Access Compliance Report

Public Rights-of-Way

(Curb Ramps)

Intersection ID: 30551	Main Street: EDENDERRY_DR	Cross Street: WEDDINGTON_RD	Location: NW
ADA ID: 39EEDEA2110A	Ramp Type: Perp	Initial Pass/Fail: Fail	Overall Compliance: No
Severity Score: 8.75			
Codes/Mitigation Info/Possible Solution		Field Measurements/Component Compliance

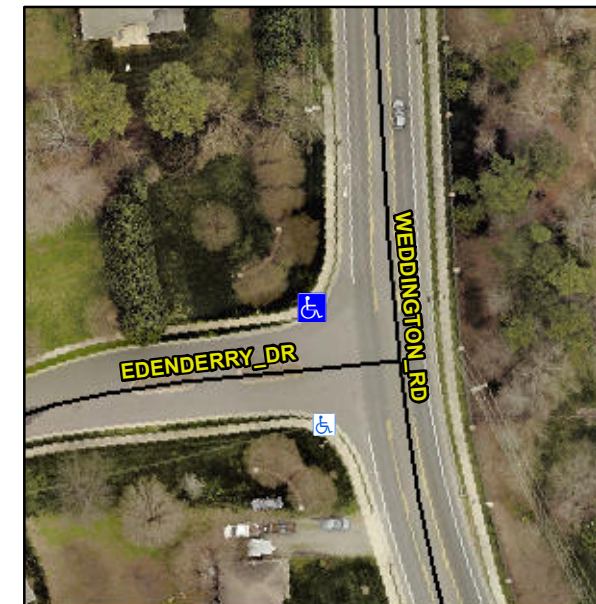
Not Found, R304.5.1

Compliance	Description	Data	Compliance	Description	Data
N/A	Ramp Length (in)	72.0	Yes	Ramp Slope (%)	6.4
No	Ramp Width (in)	45.5	Yes	Ramp XSlope (%)	0.6
N/A	Flare Type LT	N/A	N/A	Flare Type RT	N/A
N/A	Flare Slope LT (%)	N/A	N/A	Flare Slope RT (%)	N/A
N/A	Flare Traversable LT?	N/A	N/A	Flare Traversable RT?	N/A
N/A	Landing Length (in)	N/A	N/A	DWS Provided?	N/A
N/A	Landing Width (in)	N/A	N/A	DWS Contrast?	N/A
N/A	Landing Slope (%)	N/A	N/A	DWS Length (in)	N/A
N/A	Landing X Slope (%)	N/A	N/A	DWS Full Width?	N/A
N/A	Landing Curb? (Y/N)	N/A	N/A	DWS Offset (in)	N/A
N/A	Shared Landing?	N/A			
N/A	Gutter Ponding?	N/A	N/A	Gutter Slope (%)	N/A
N/A	Gutter Lip Ht (in)	N/A	N/A	Gutter X Slope (%)	N/A
N/A	Painted X Walk1?	No	N/A	Painted X Walk2?	N/A
	X Walk 1 Direction	To S		X Walk 2 Direction	N/A
N/A	X Walk 1 Width (in)	N/A	N/A	X Walk 2 Width (in)	N/A
	X Walk 1 Slope (%)	2.9		X Walk 2 Slope (%)	N/A
	X Walk 1 X Slope (%)	3.1		X Walk 2 X Slope (%)	N/A

Remove & Replace Entire Ramp.
